WORK INSPECTION REQUEST (WIR) FORM

Contractor:	HAIF-FREYSSINET JV
Project:	RA2RC
Contract No.:	QPMO-410-CT-00618
Work Inspection Request Number:	QRXM114000-HFC-TEC-WIR-ITS-02-RO5-00093

Inspection request for Installation of Traffic signal Gantry (Cantilever), Junction-3 (15.5 mtr),at Access to Resort core interim Road. As per attached drawing.

Project Name: Package 3 - Interim Road Access to Resort Core	**Project Code:** QRXM114000
**Location: RA2RC ** Qiddiya INTERM ROAD	**Date:** 13-June-2026
Document Title: Method of Statement for Traffic Signal System Installation and Commissioning	Ref No: QRXM114000-HFC-TEC-MST-ITS-02-RO5-00002
	Rev No: 00

Drawing title:
SHOPDRAWING OF TRAFFIC SIGNAL SYSTEM FOR JUNCTION-3
TYPICAL DETAILS-1

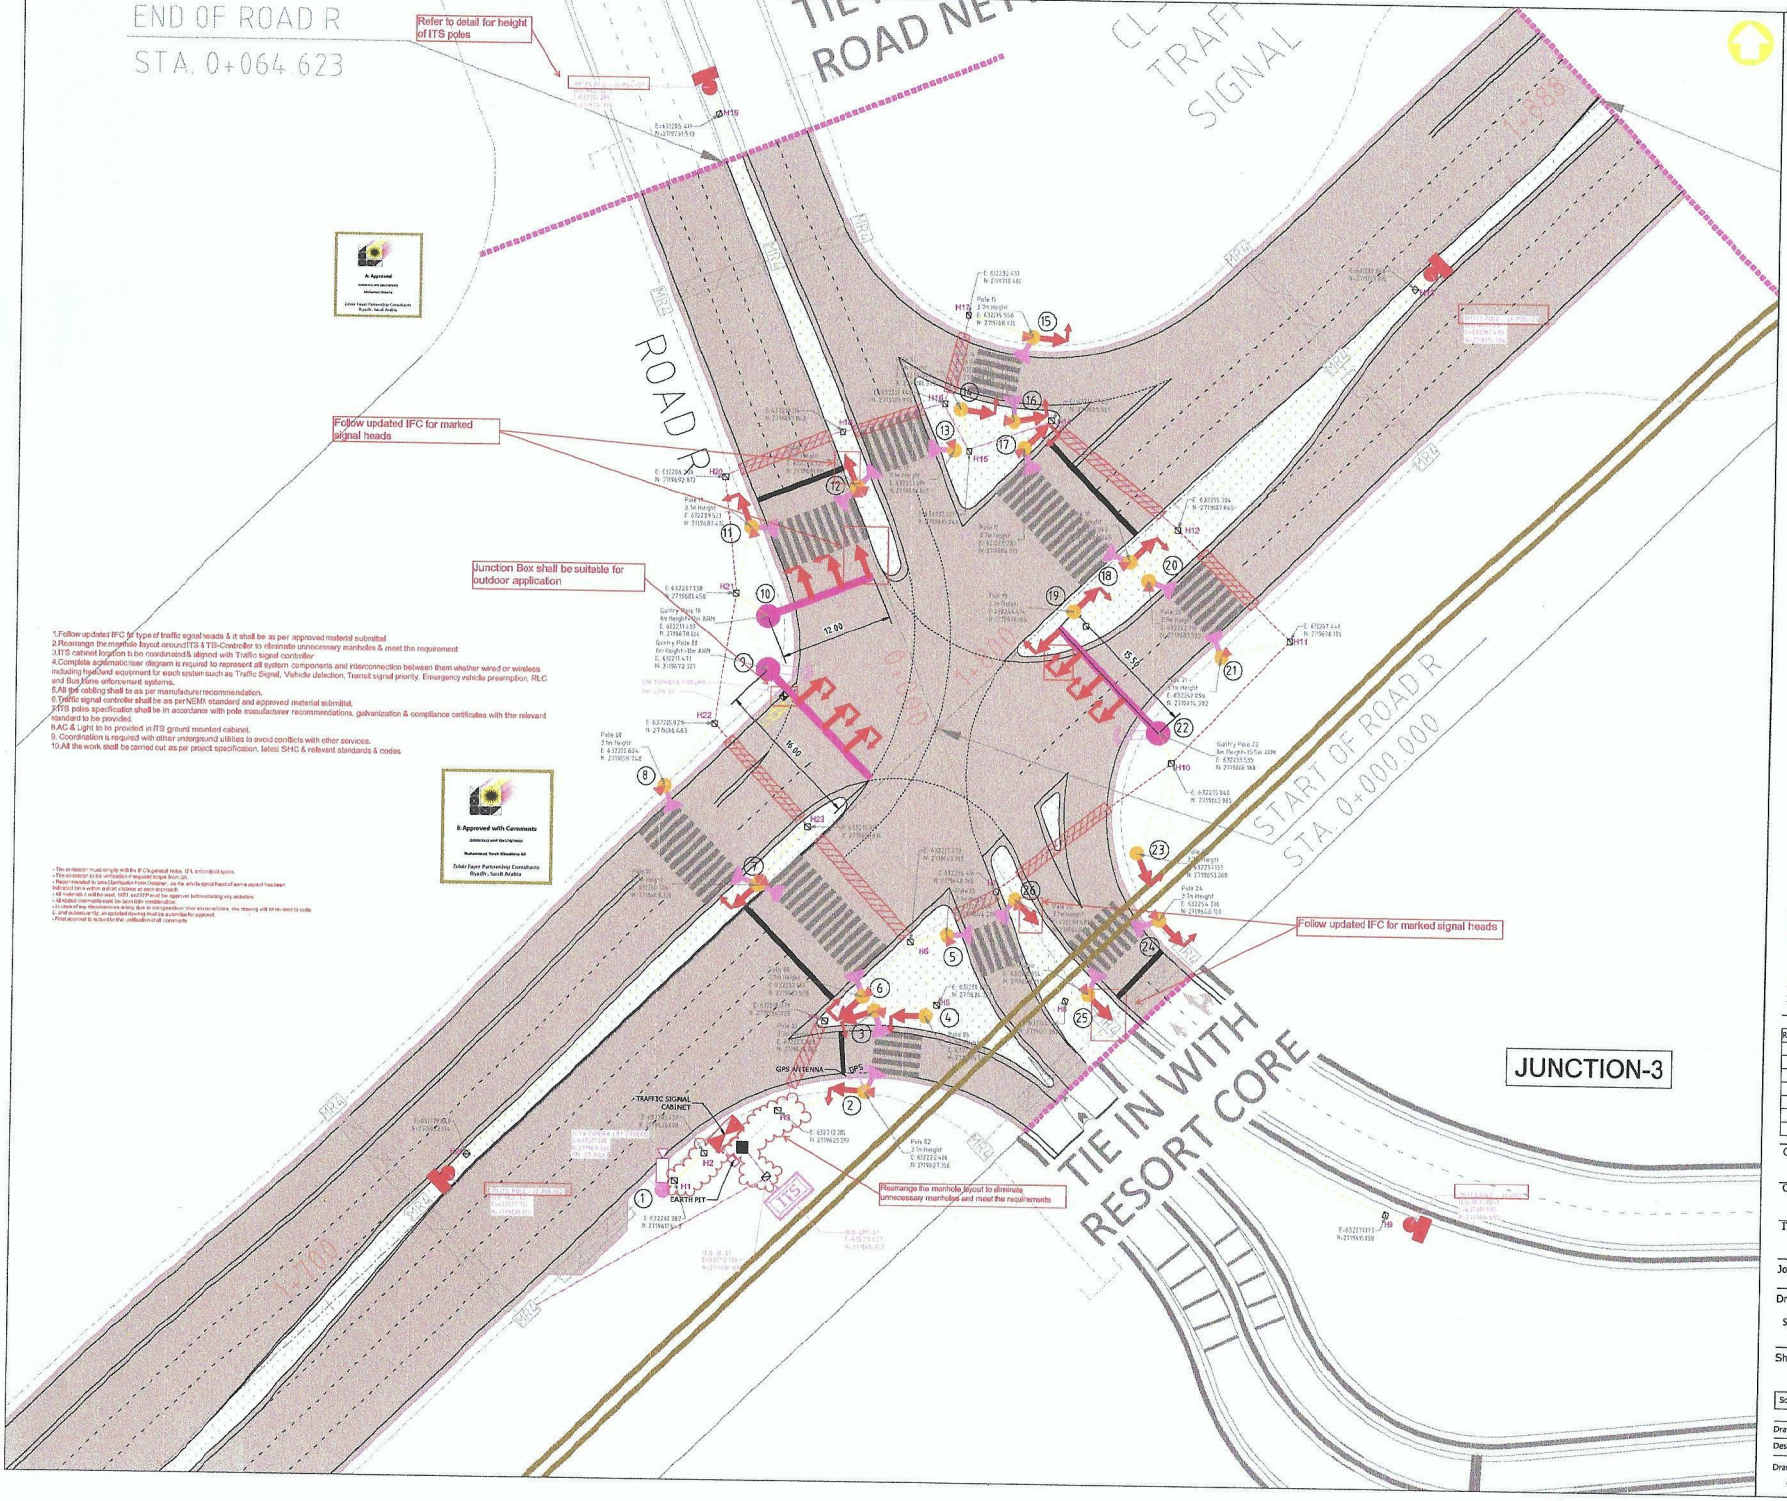
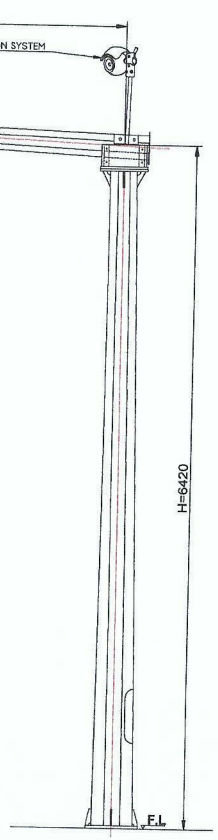
A-Approved
For comments refer to the drawing # QRXM114000-HFC-DRW-SDW-ITS-02-RO5-00033

All general comments notes or drawing and previous Rev. shall be maintained
A-Approved
Zuhair Fayez Partnership Consultants
Riyadh - Saudi Arabia
